CITY OF OPELIKA
HISTORIC PRESERVATION COMMISSION
April 13, 2023
4:30 p.m.
Meeting Chambers at Opelika Municipal Courtroom
300 MLK Boulevard

City of Opelika
Historic Preservation Commission
Staff Report

Agenda Item #: 1
Meeting Date: 04/13/2023
Action Requested: COA: Iron Fence
Location of Property: 715 Ave D; Geneva Historic District
Petitioner: Pam Pouncy

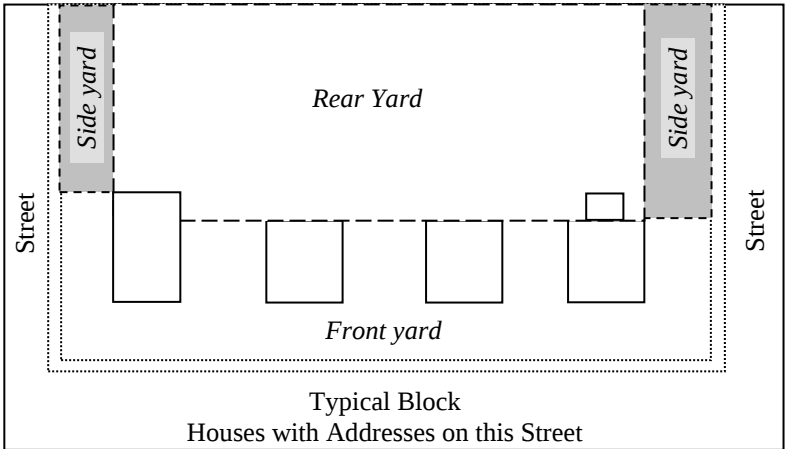
- 1. Install 29ft of fence line facing 8th Street of 5ft tall antique iron/metal fence cut into 5ft sections to include two sections of fence and a gate. The fence will be refinished with finials added.

1. Staff recommends approval of installation of iron fence with finials.

Location of proposed fence and deck

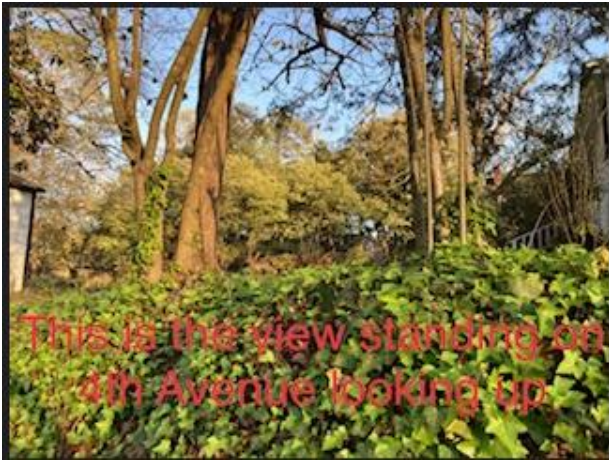
- 1. Install 50ft of 6ft high cedar and pine privacy fence along 4th Ave.
- 2. Install 12ft x 20ft deck using Trex composite decking and 42” high railing of Trex composite material.

1. Staff recommends approval of standing cedar and pine privacy fence along side yard facing 4th Ave.
2. Staff recommends approval of rear deck of Trex material not visible from the street.

#1 Aluminum 12”x12” panel sign at entry

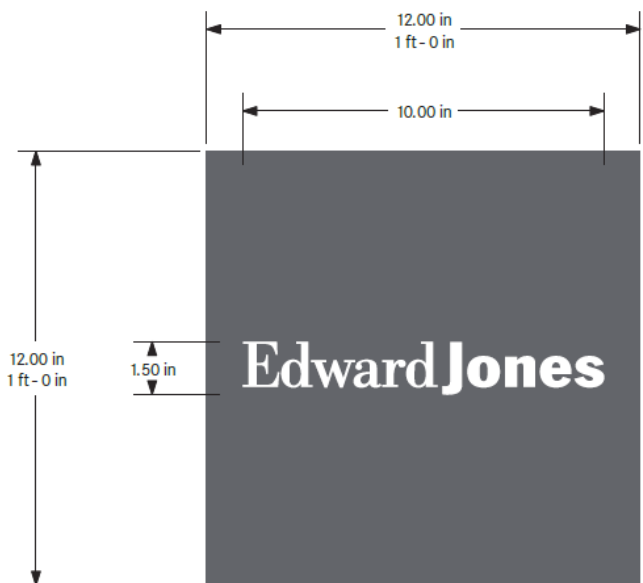
1. Install one 12" x 12" aluminum pan panel with applied vinyl edges bent to 1" D with corners welded and ground smooth on front façade at entry.
2. Install 5' x 4'1" (20sf) non-illuminated grey monument sign with aluminum base, Lexan panels with applied white vinyl lettering.

1. *Staff recommends approval of panel sign at entry.*
2. *Staff does not recommend approval of metal base monument sign for it does not meet standard #1 of guidelines as “ texture of materials, color, and design of signs shall be in keeping with the collective characteristics of the structures surrounding the property on which the sign will be located.”*
